Location Address: 1225 N17th CT

Explanation of Request: SITE PLAN APPROVAL OF A 15 UNIT RESIDENTIAL DEVELOPMENT

PRELIMINARY TAC RESPONSE TO COMMENTS

ARTHUR STREET APARTMENTS
1225 N 17th CT
HOLLYWOOD, FL 33020

SITE PLAN

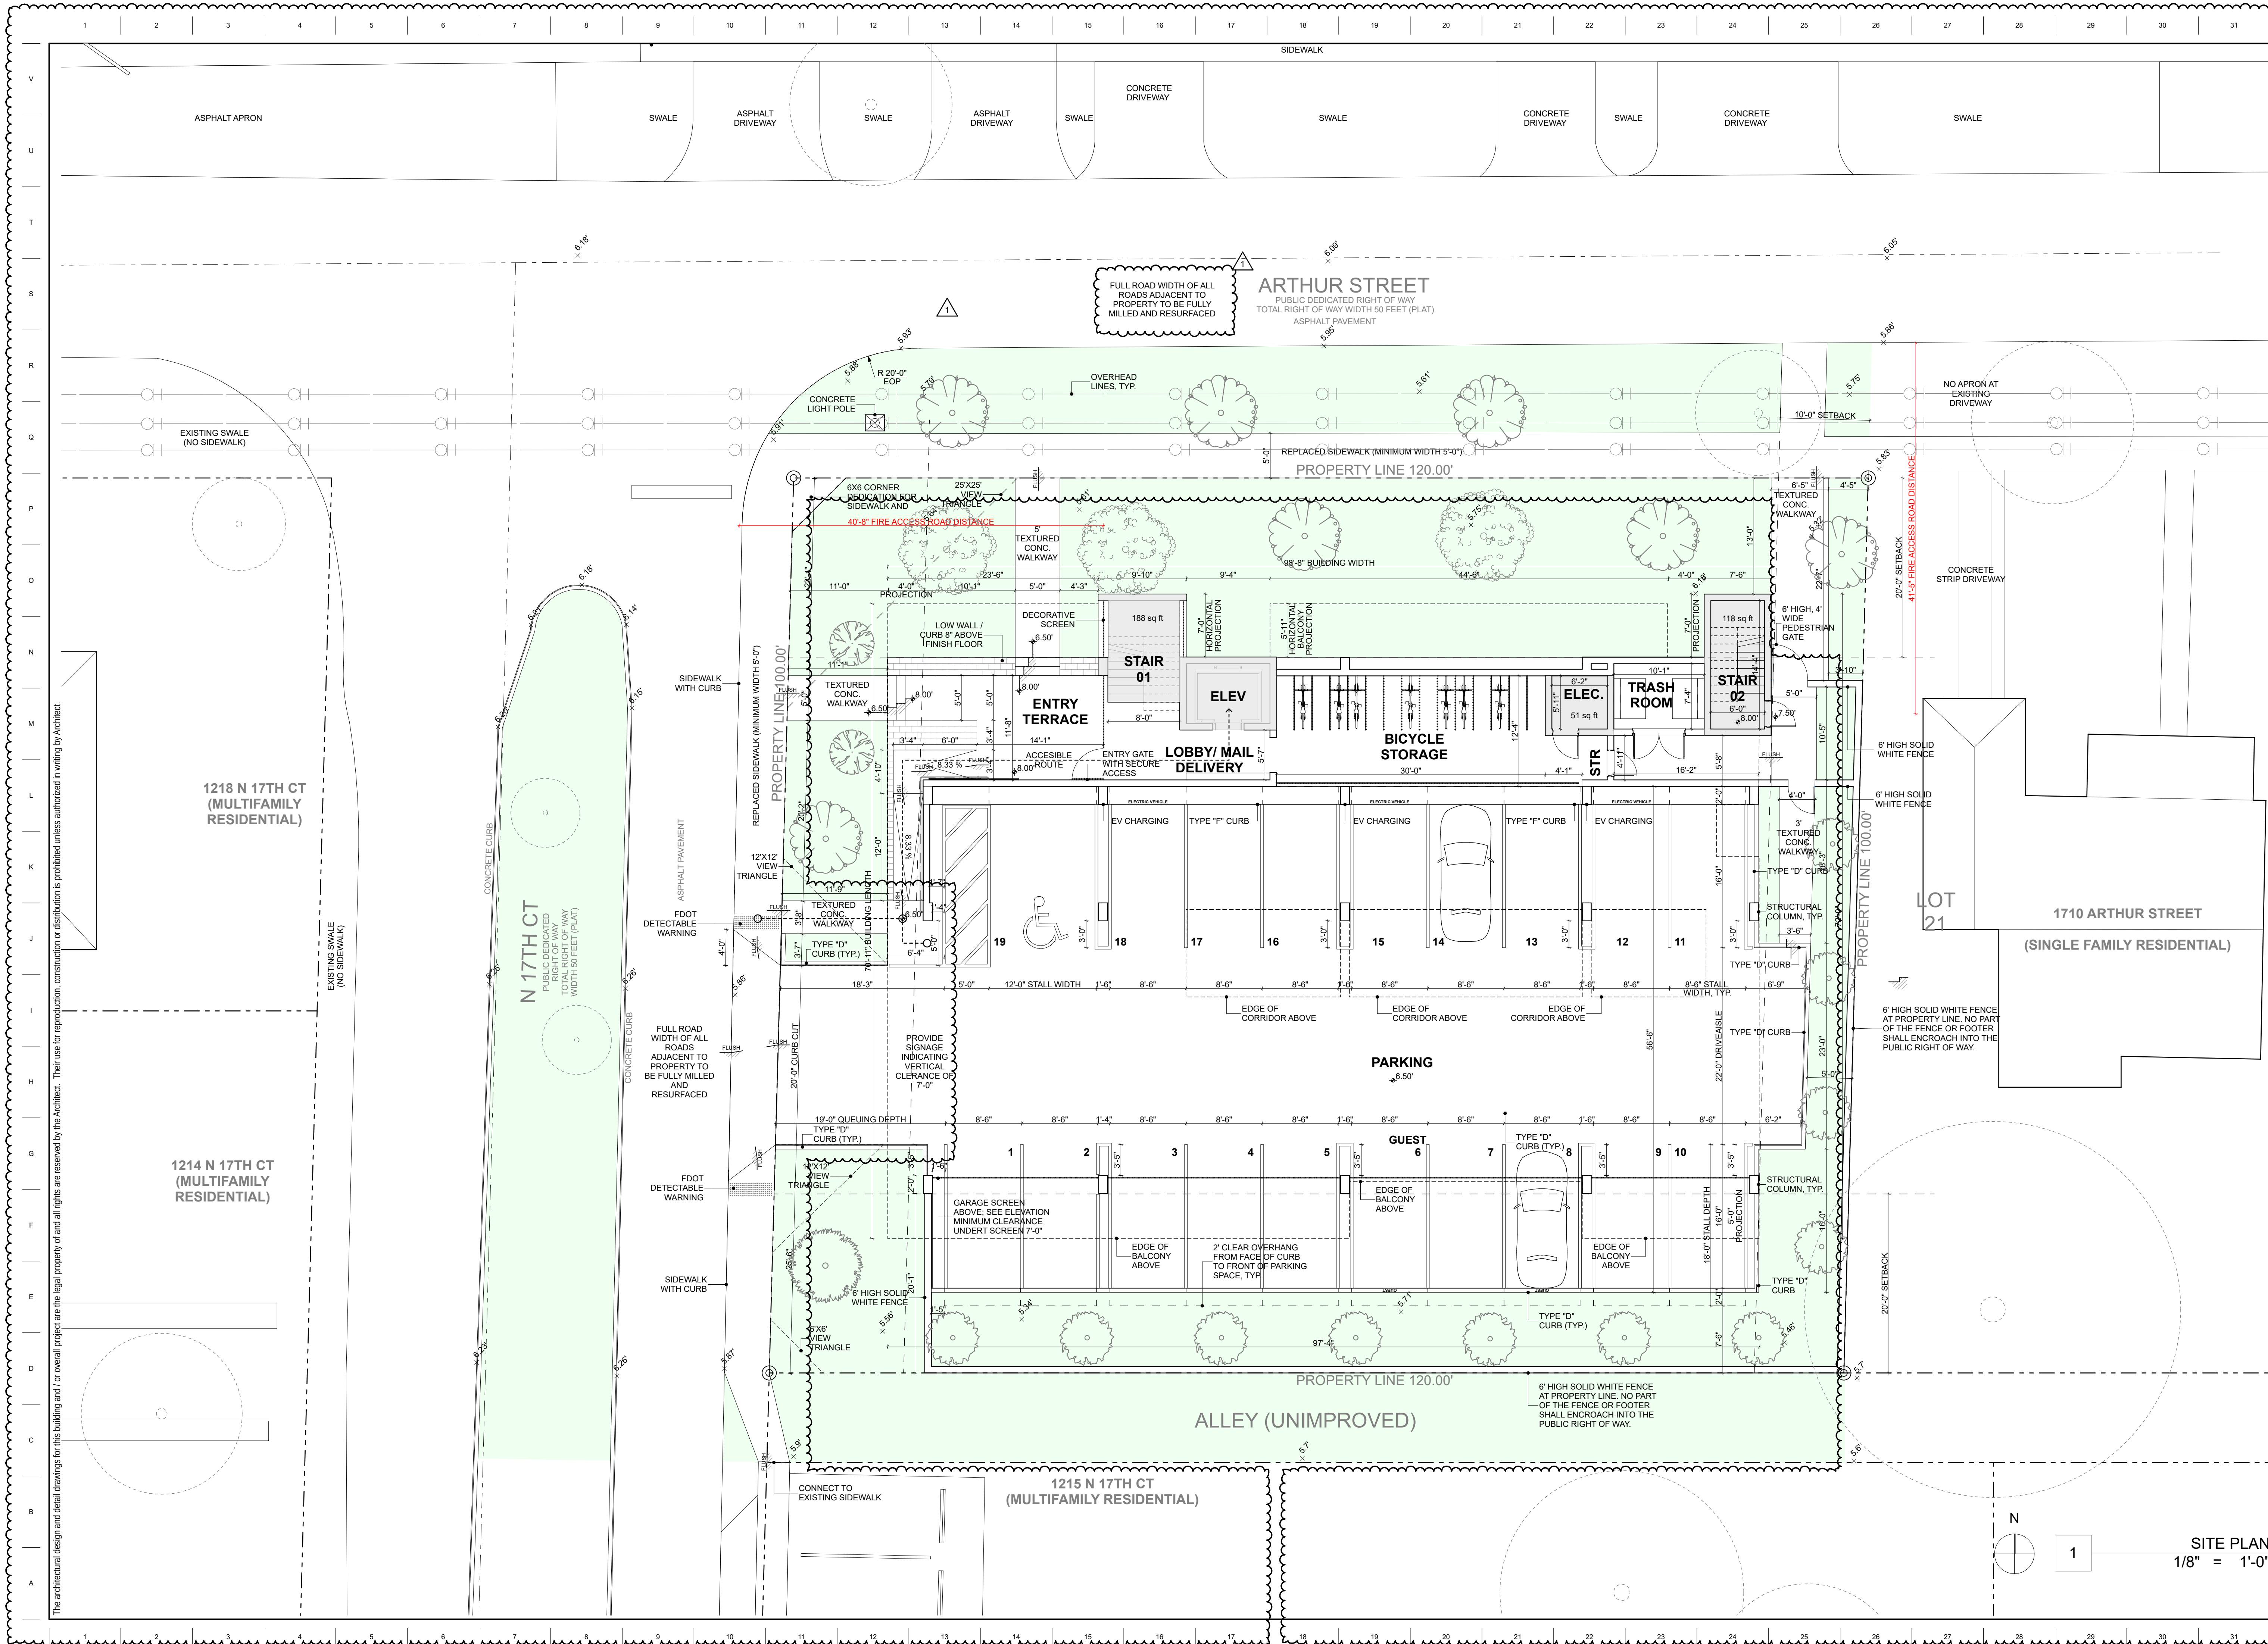
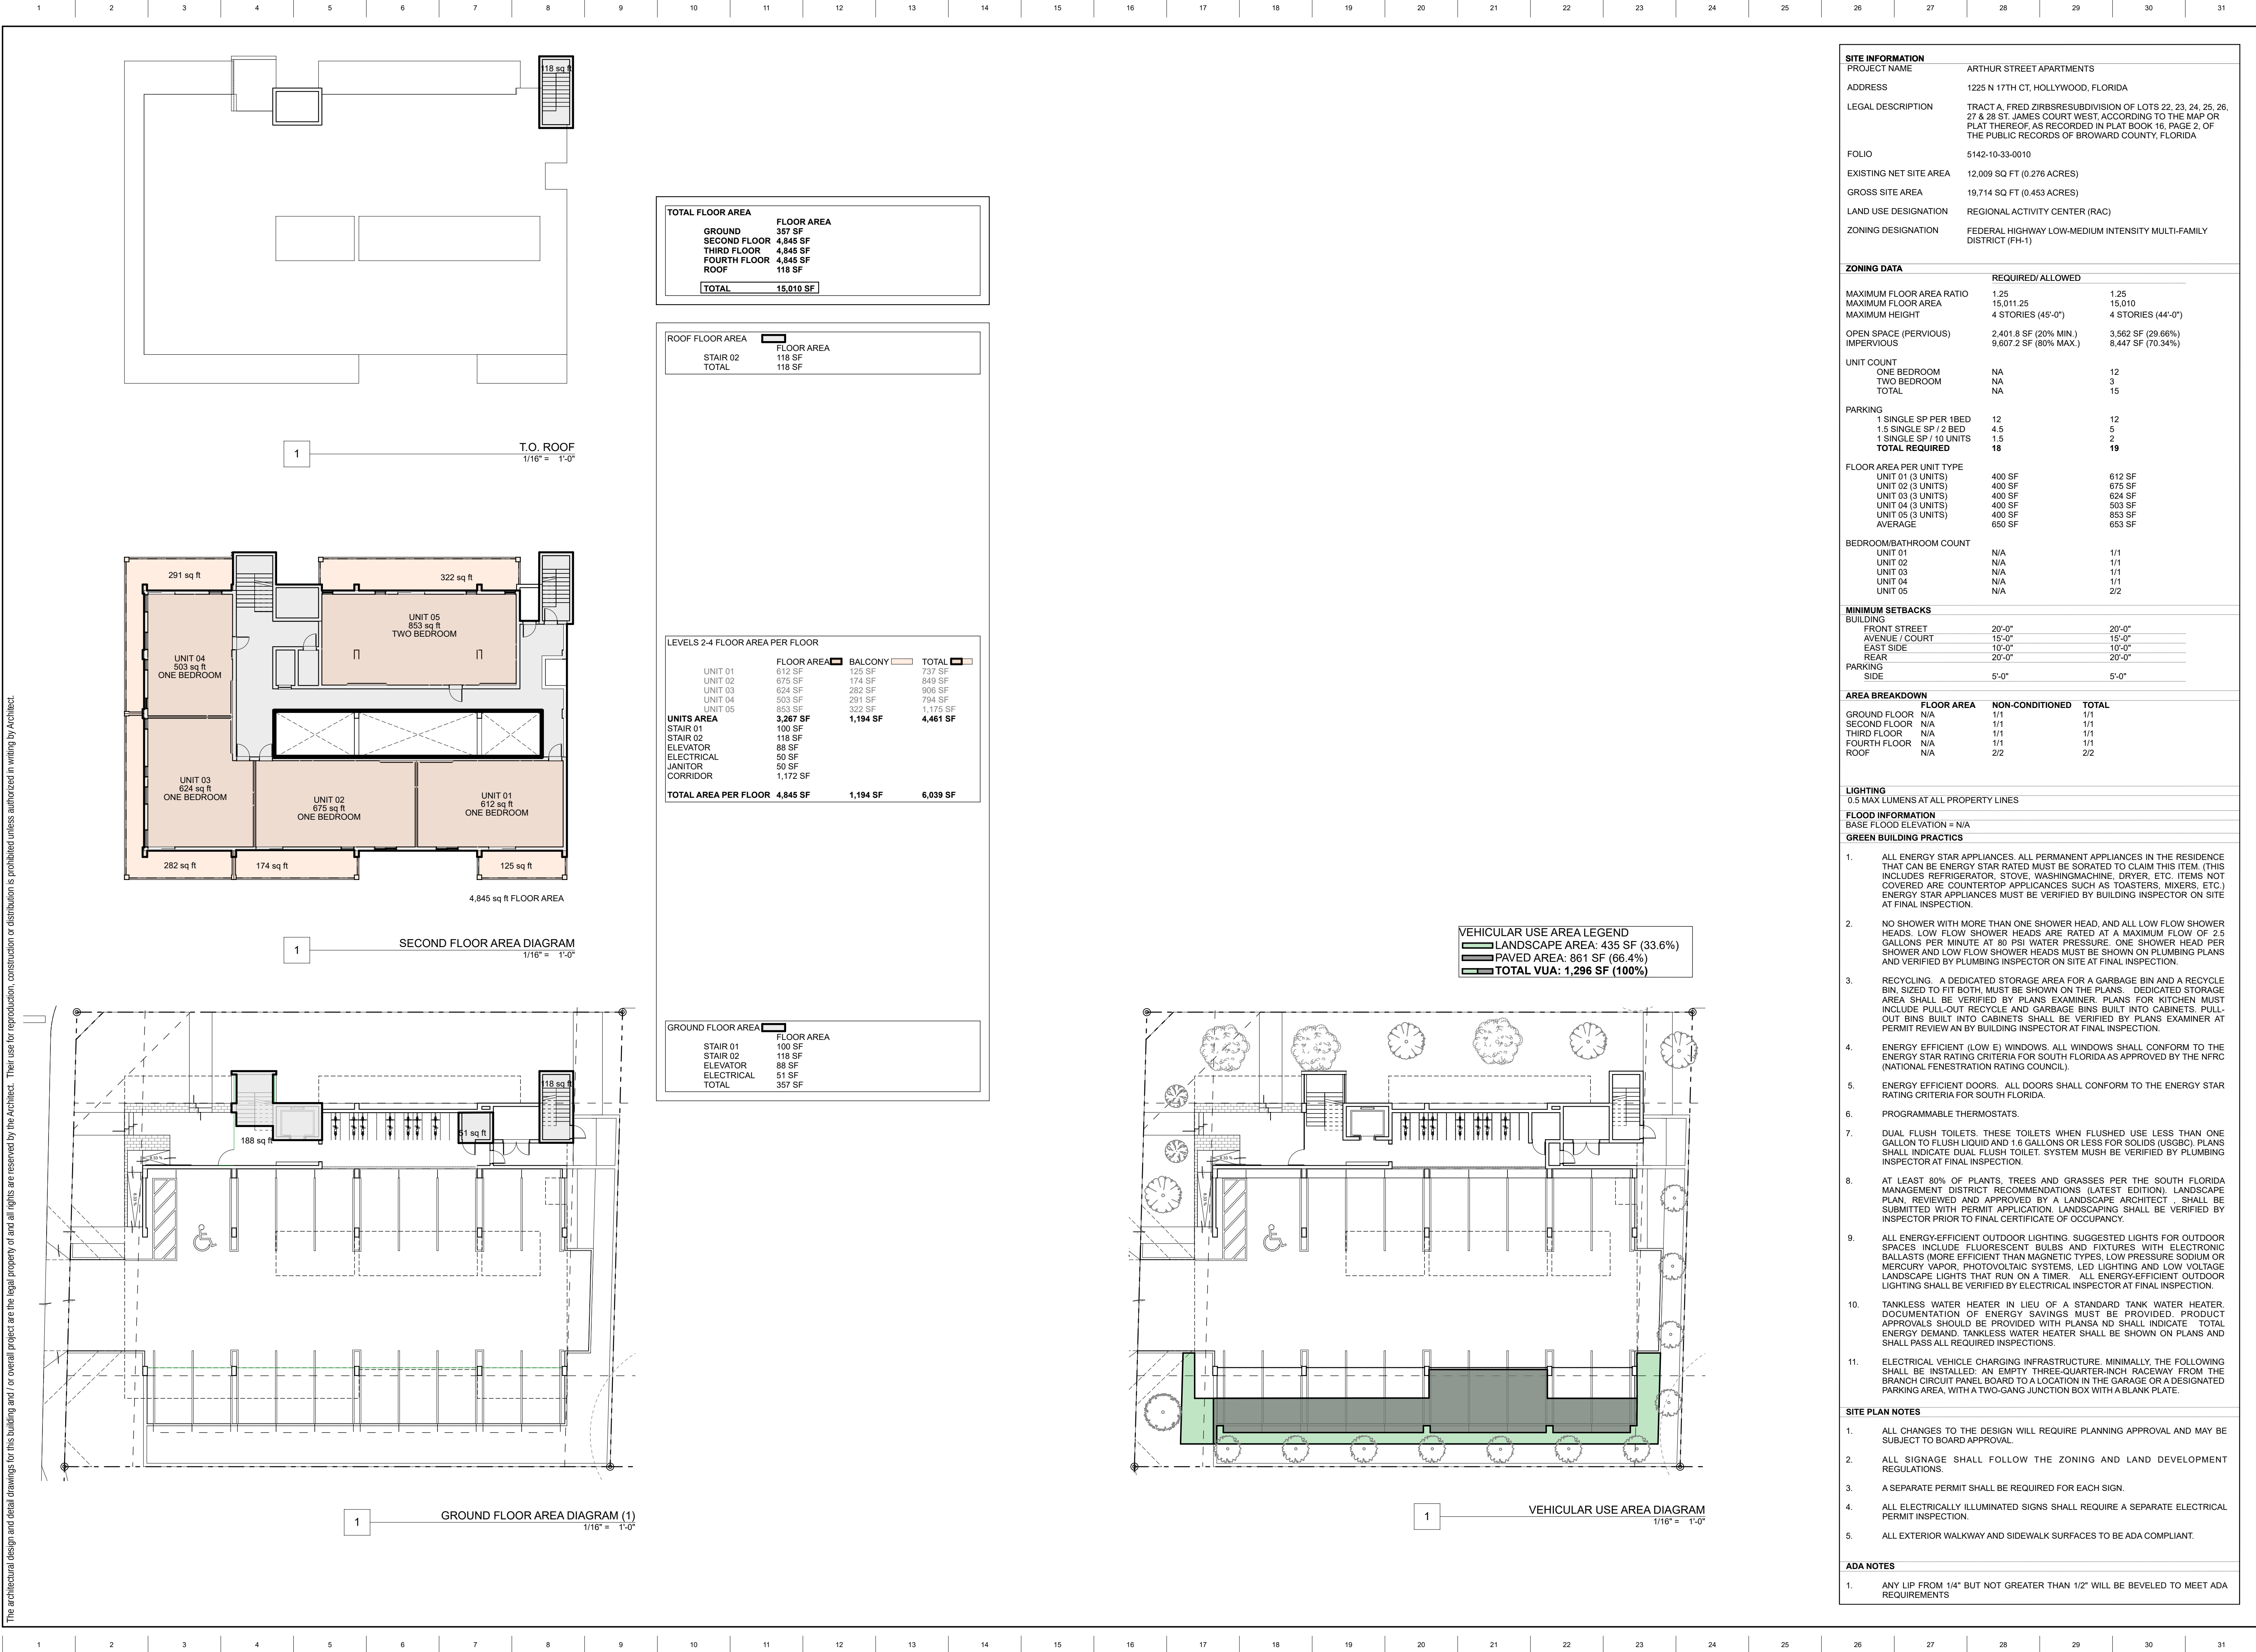
3. Please provide an overall site plan for the project showing all surrounding areas and all sides of the site, including adjacent properties and all features of City streets and alleys within full City right-of-way from property line to adjacent property lines. (Swales, sidewalks, gutters along entire property frontage, edge of pavement and any adjacent features such as neighboring driveways etc. both sides of the street or alley within full right-of-way width on the alley, 17th Court and Arthur Street).

4. Please show sidewalk connectivity adjacent to the site (i.e., adjacent properties' sidewalk and crosswalks etc.), include any ADA ramps.

7. Provide a 6'X6' corner dedication at the intersection of Arthur Street and North 17th Court to accommodate public sidewalk with ADA ramp at the northwest corner of the site. Please show all proposed improvements on all plans accordingly.

RESPONSE: Noted. See landscape plan Sheet L200
16. Queuing depth is to be a minimum of 19 feet. Plan shows south side will only have a queuing depth of 16'-7". Please address.

18. Provide ADA accessible routes between ADA accessible parking and building access and accessible route to the public rights-of-way. Please add a note on the site plan stating any lip from 1/4" but not greater than 1/2" will be beveled to meet ADA requirements. Identify any elevation differences or slopes from the sidewalk in the ROW and accessible parking stall to the entrance of the building. If there is no difference state, the transition is flush. Show the accessible routes on site plan. Provide a detail for the proposed ramps showing how they achieve ADA compliance.

RESPONSE: Site plan extended to include adjacent properties. See Sheet A001.

RESPONSE: Connections to existing sidewalks provided on sheet A001.

RESPONSE: Corner dedication provided. See sheet A001
8. Sidewalk shall be flush and continuous through driveway opening.
RESPONSE: Flush sidewalk markings noted on the plan.

RESPONSE: Queuing depth adjusted to 19'-0" See sheet A001.
17. Provide the vertical clearance of the garage on the site plan.
RESPONSE: Note for minimum vertical clearance provided on site plan Sheet A001.

RESPONSE: ADA Route added to site plan SheetA001. Sheet Graphic indication of Flush Areas provided.
19. Please fully dimension the parking garage, there appears to be space between the ADA accessible aisle and the wall, please identify this distance.
